ADDENDUM

SUBJECT: **Addendum to Item Th12b:** Coastal Development Permit Application No. 5-15-0751, scheduled for the Commission meeting of April 14, 2016

Re: Coastal Development Permit Application No. 5-15-0571 (Foxdale),
19 Bay Drive, Laguna Beach

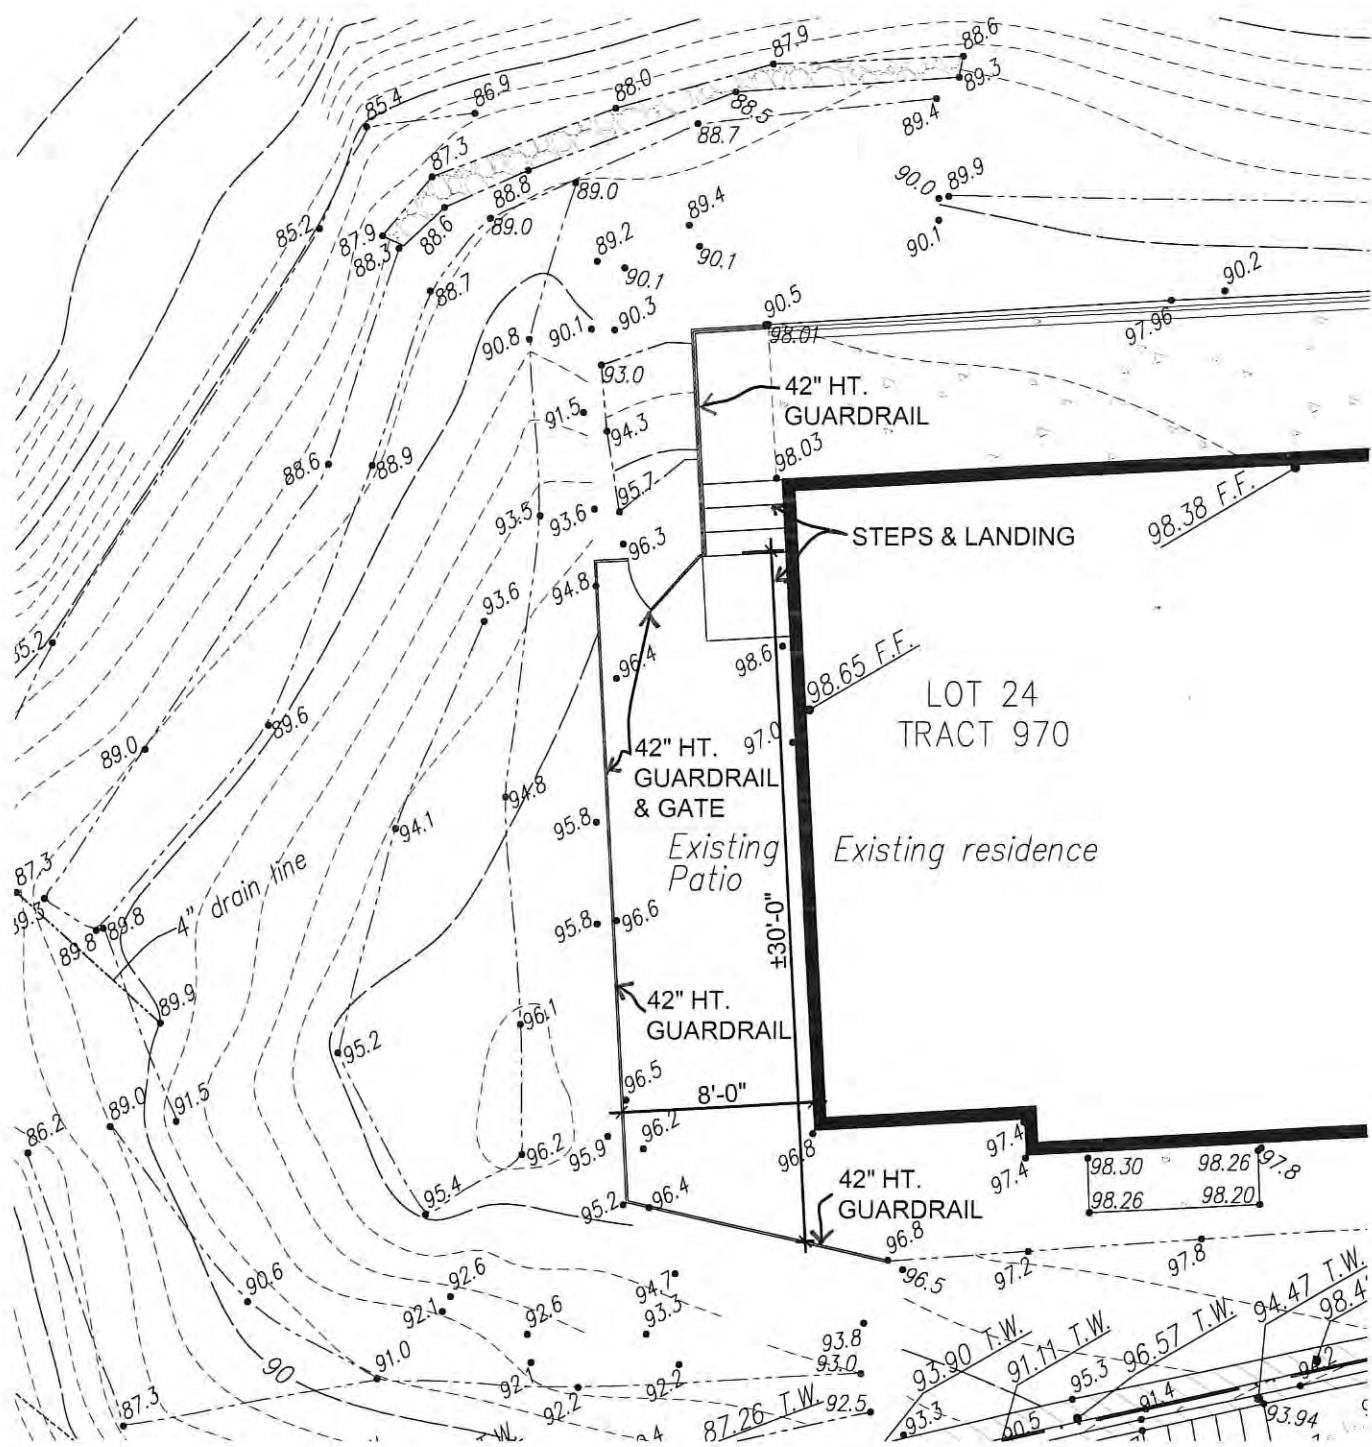
I have attached the stringline drawing which I believe appropriately carries out the stringline policy. With the bluff edge setback, there is little reason to apply an inappropriate stringline to control development as well.

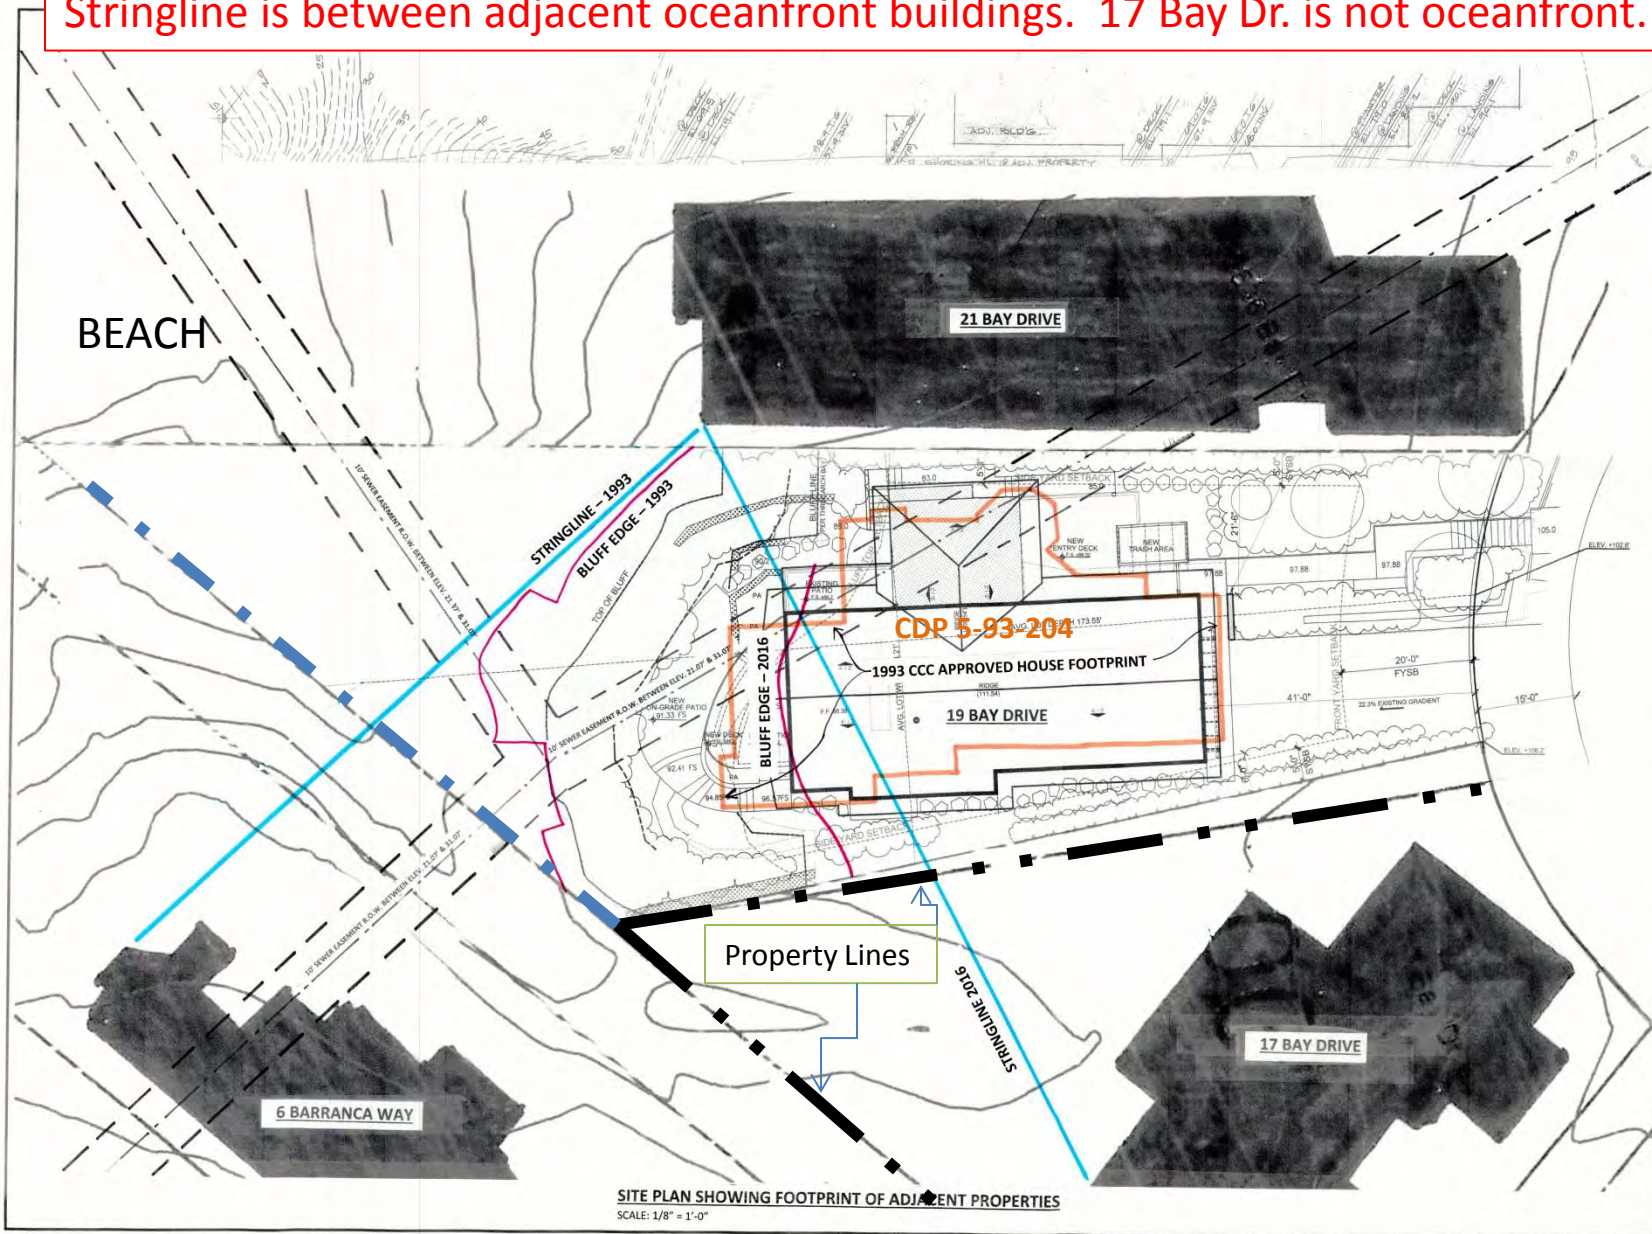
Stringline is between adjacent oceanfront buildings. 17 Bay Dr. is not oceanfront.

The deck and patio are far smaller than those permitted at other Bay Drive Homes

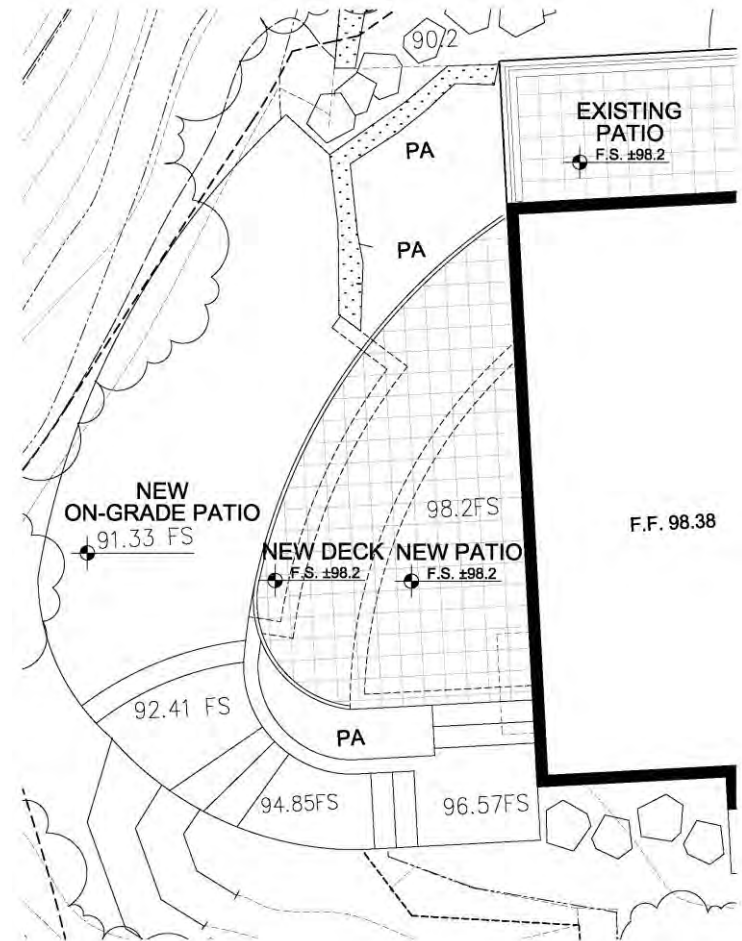
The 276 square foot curved deck would be outside the main floor at elevation 98.2.

The 388 square foot Permeable surface patio At elevation 91.

Special Condition No. 1 removes the deck and on grade patio shown here. The deck is a concrete deck at the floor level of the home. The on-grade patio is a permeable surface patio with a small bench inset under the overhang of the deck. The deck and patio both assure stability and structural integrity. The deck and patio provide outdoor space to enjoy the views of the ocean in the manner which every house on Bay Drive enjoys.

ADDED DECK AND BEDROOM FOUNDATION PLAN

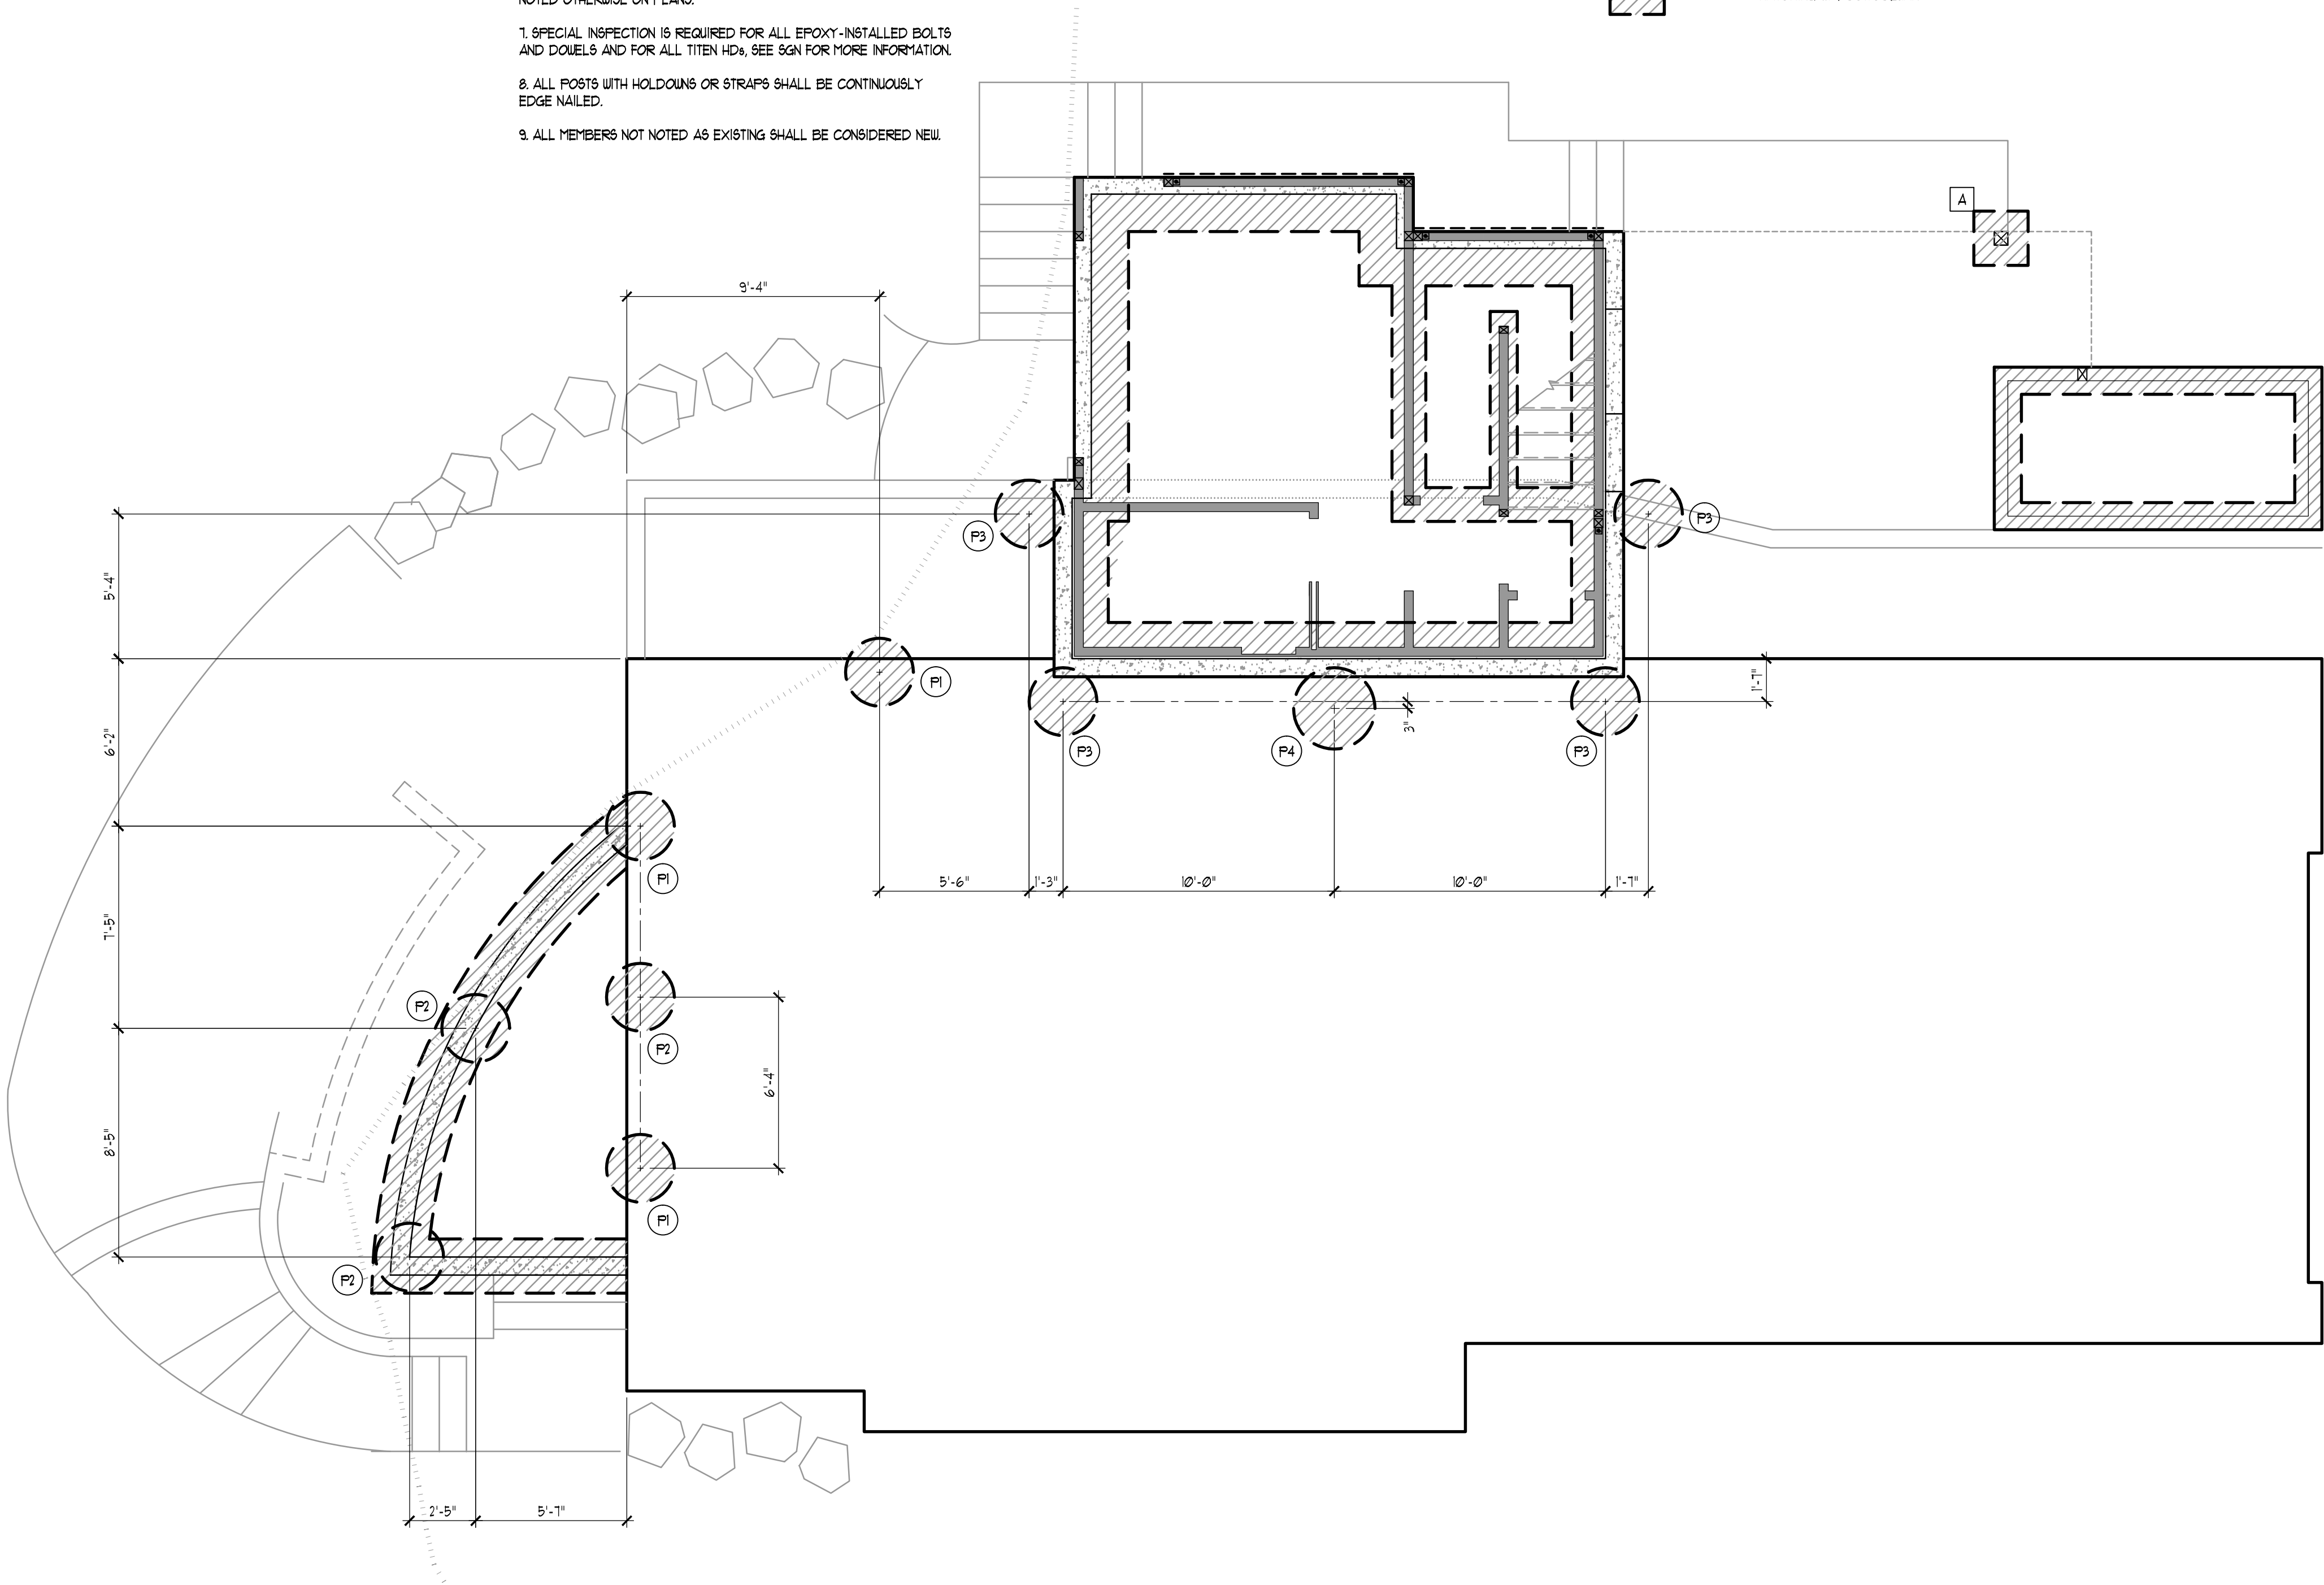
- B. The proposed deck, caissons, structural support, and associated patio seaward of the southern wall identified on the plans submitted June 12, 2015 shall be removed from the final plans.

PLATE 2 Geotechnical Cross Section A-A'
19 BAY DRIVE
LAGUNA BEACH, CALIFORNIA
ViaGeos

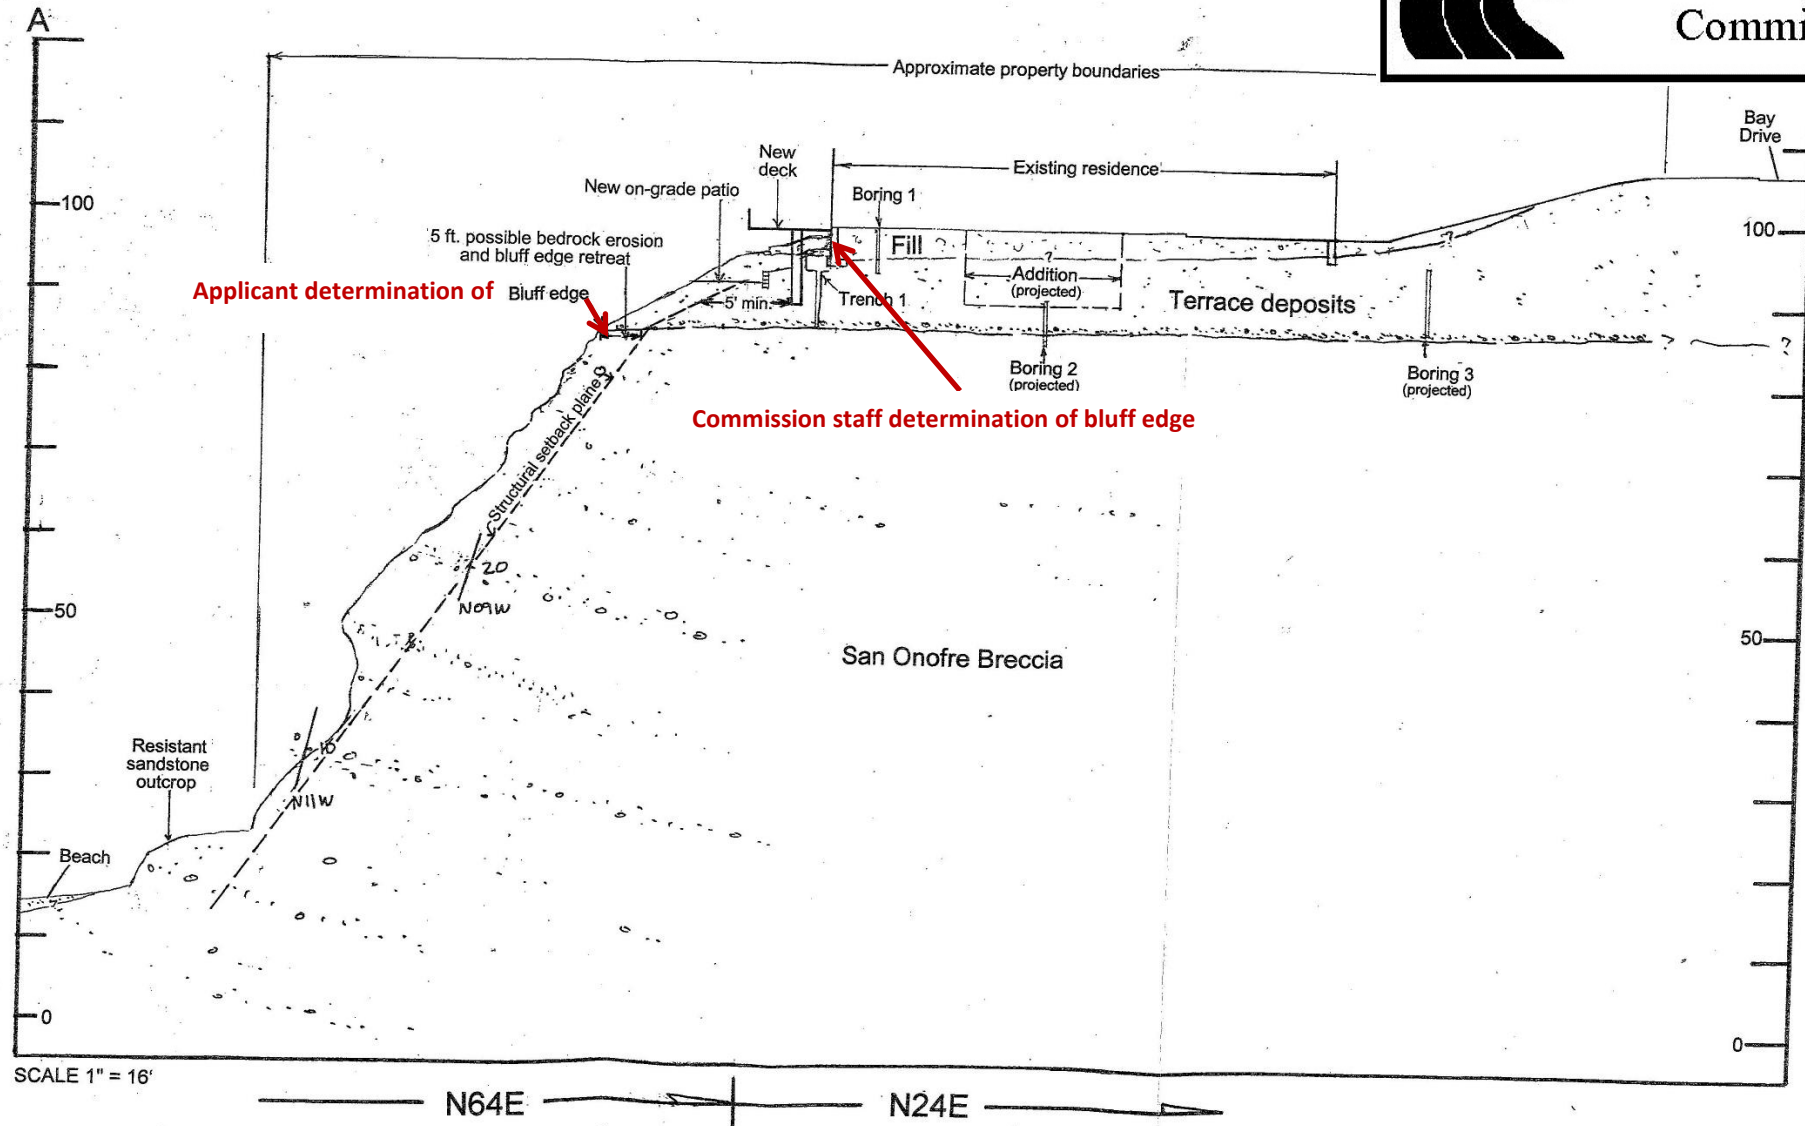
The Commission's staff geologist, Dr. Mark Johnsson, visited the site on March 11, 2016 and reviewed the applicant's geotechnical analysis, bluff edge determination, and proposed architectural and foundation plans. Dr. Johnsson determined that the applicant's bluff edge determination is not consistent with the definition of bluff edge in section 13577(h)(2) of the Commission's regulations.

Based on the definitions of bluff edge in the Commission’s regulations, the Laguna Beach Land Use Element, and the Three Arch Bay Zoning Code, Coastal Commission staff identified the bluff edge as depicted in **Exhibit 5**, seaward of which a downward gradient is maintained continuously to the base of the bluff, with a steplike feature created by the filled material near the southern wall of the structure. The ocean fronting bluff edge is at approximately the 97 foot elevation contour line, where the applicant’s plans show the 25 foot blufftop setback line. The applicant’s bluff edge determination and the correct bluff edge location can be interpreted from the geotechnical cross section in **Exhibit 4**, which shows the continuous downward gradient beginning under the southern wall of the existing home. The applicant misidentifies the bluff edge at the point which is actually the sea cliff, further down the bluff. The applicant’s bluff edge analysis appears to be based on the Laguna Beach Zoning Code, which states that the bluff edge is the point at which a 45 degree downward angle begins and the bluff descends to the beach, but this definition is neither consistent with the definition of bluff edge in the Commission’s regulations, which is used to determine the appropriate siting of the development so that it can be consistent with section 30253 of the Coastal Act, which is the standard of review, nor is it consistent with the certified Laguna Beach Land Use Element, which prevails over the zoning code in cases of conflict.
